Township of Gloucester
Planning Board Agenda
March 14, 2017

#162063CM **Larry & Marc, LLC**	**Minor Site Plan/Bulk C Variance** **Block: 12616 Lot: 2** **Location: 16 Dearborne Avenue Blackwood, NJ** **Zoned: NC** **24 x 40 commercial garage, 10 10'x20'Commercial Shed & 8'x 13' Commercial Storage Shed**

FROM: Kenneth D. Lechner, PP, AICP, Director/Planner
Department of Community Development & Planning

Re: Minor Site Plan with Bulk Variances
Larry & Marc, LLC
16 Dearborne Avenue
Blackwood, NJ
Block 12616, Lot 2
Review No. 1
Bach Project No. GTPB-2017-2

Shed 1 Front and Side View

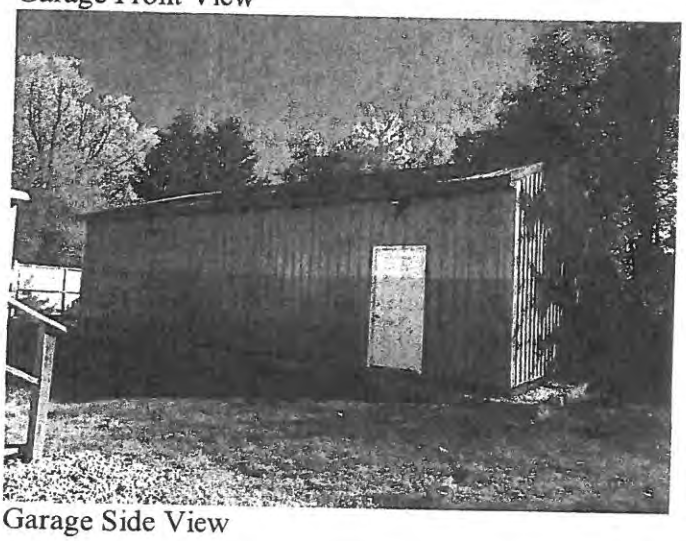
1. *The architect must address the required exterior wall fire ratings for shed 1 & shed 2.*
2. *Architectural plans including foundation designs for all 3 structures will be required.*

2-13-17 JTG Bldg - (1) The Architect must address the required exterior wall Fire Ratings for Shed 1 + Shed 2
(2) Architectural plans - including foundation designs for all 3 structures will be required.
